Access Compliance Report

Public Rights-of-Way

(Curb Ramps)

Intersection ID: 45174	Main Street: LINDEN_TREE_LN	Cross Street: SOCIETY_ST	Location:	SE
ADA ID: 5E052F8FFEAA	Ramp Type: Perpendicular Diagonal	Initial Pass/Fail: Fail	Overall Compliance: No	Severity Score: 10
Codes/Mitigation Info/Possible Solution		Field Measurements/Component Compliance

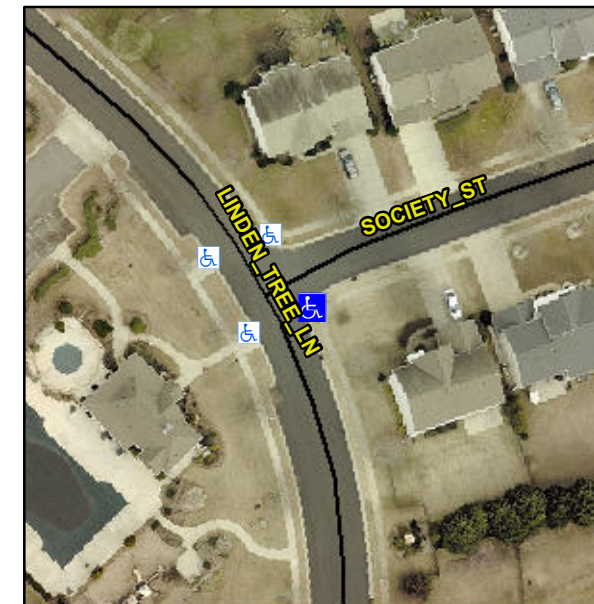
Not Found, R304.5.1, R304.5.3

Compliance	Description	Data	Compliance	Description	Data
N/A	Ramp Length (in)	47.0	Yes	Ramp Slope (%)	5.4
No	Ramp Width (in)	47.0	No	Ramp XSlope (%)	4.3
N/A	Flare Type LT	N/A	N/A	Flare Type RT	N/A
N/A	Flare Slope LT (%)	N/A	N/A	Flare Slope RT (%)	N/A
N/A	Flare Traversable LT?	N/A	N/A	Flare Traversable RT?	N/A
N/A	Landing Length (in)	N/A	N/A	DWS Provided?	N/A
N/A	Landing Width (in)	N/A	N/A	DWS Contrast?	N/A
N/A	Landing Slope (%)	N/A	N/A	DWS Length (in)	N/A
N/A	Landing X Slope (%)	N/A	N/A	DWS Full Width?	N/A
N/A	Landing Curb? (Y/N)	N/A	N/A	DWS Offset (in)	N/A
N/A	Shared Landing?	N/A			
N/A	Gutter Ponding?	N/A	N/A	Gutter Slope (%)	N/A
N/A	Gutter Lip Ht (in)	N/A	N/A	Gutter X Slope (%)	N/A
N/A	Painted X Walk1?	No	N/A	Painted X Walk2?	No
	X Walk 1 Direction	To NW		X Walk 2 Direction	To SW
N/A	X Walk 1 Width (in)	N/A	N/A	X Walk 2 Width (in)	N/A
	X Walk 1 Slope (%)	3.2		X Walk 2 Slope (%)	0.0
	X Walk 1 X Slope (%)	1.8		X Walk 2 X Slope (%)	2.0

Remove & Replace Curb Ramp With Two New Directional Ramps or Equivalent.
